## Hahamongna: “Flowing Water, Fruitful Valley”

Restoring Natural Flows to the Arroyo Seco  
An alternative plan for the Arroyo Seco Canyon Project

# The Arroyo Seco Canyon Project

This presentation is a follow on to written public comment made under the Initial Study submitted to Pasadena Water & Power in December 2019.

# Pre-storm and early storm period March 2020:

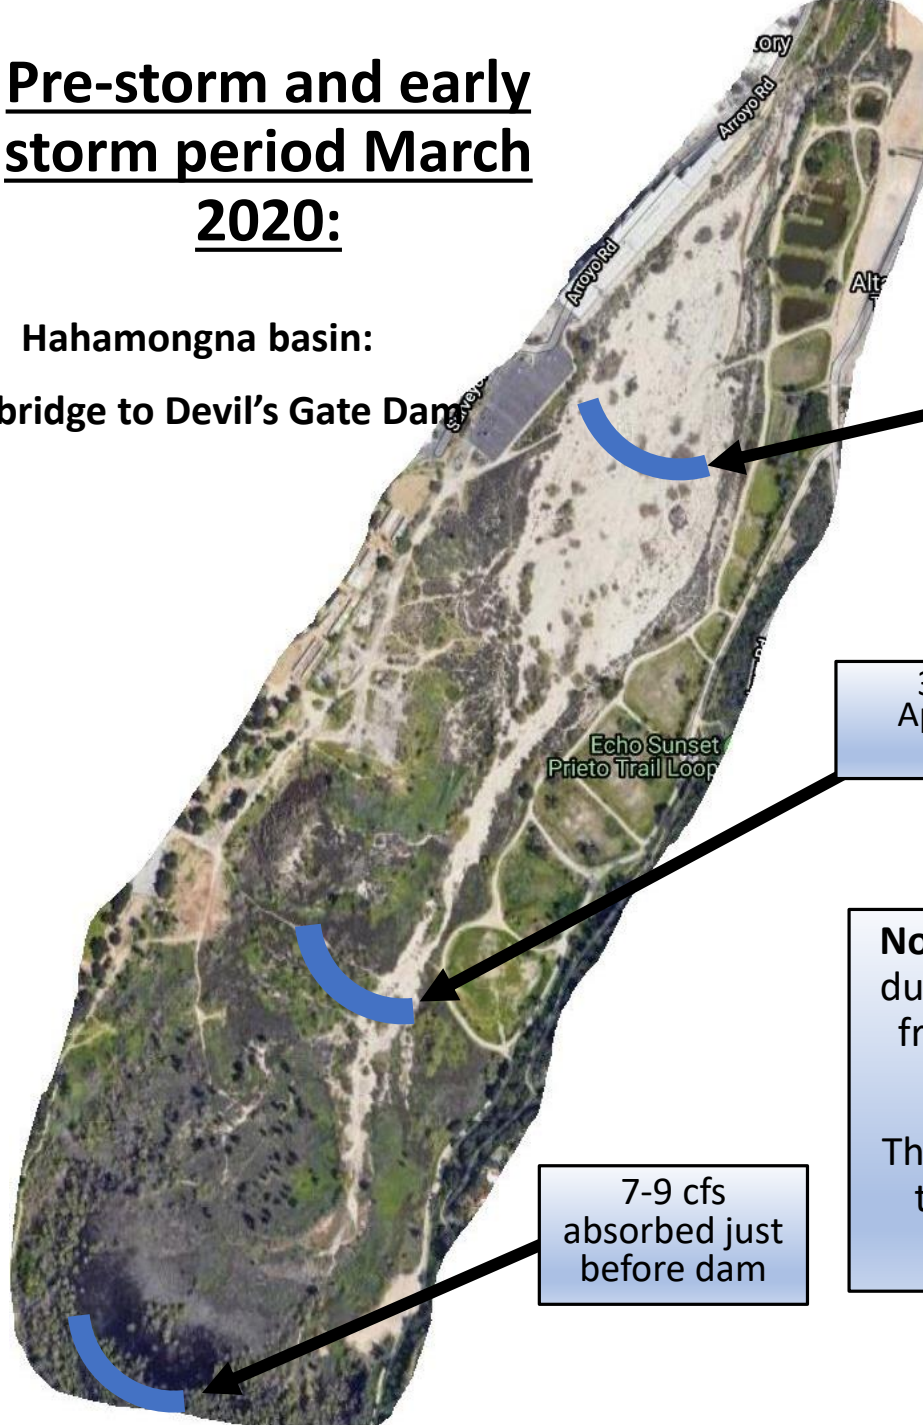
During periods without diversion natural flows were absorbed at the following points:

1-2 cfs absorbed here

3-5 cfs absorbed here. Approximately level with Johnson Field

**Note:** In 1919 LA Co. Flood Control dug a straight channel in the stream from just above Johnson Field to the dam.  
The channelization likely impacted the percolation capacity of the stream.

7-9 cfs absorbed just before dam

- ### Key Observations:
1. Hydraulic conductivity (percolation) in the stream zone is compromised since the influx of debris in 2009/10. Philip Williams, in 2000, estimated the stream could absorb up to 25 cfs before reaching the dam.
  2. Mean flows even during the rain season are 3 cfs or below. Mean flows in the Arroyo Seco, if left in the stream, are still absorbed before the stream reaches Johnson Field the last of the spreading basins. This is well before the dam.
  3. Water quality in the stream zone is substantially better than in the spreading ponds. The spreading ponds produce significant amounts of algae as soon as flows decrease.
  4. Raymond Basin Management Board could, at a minimum, award pumping credit to PWP for mean flows absorbed by the stream without jeopardizing the pumping agreement.
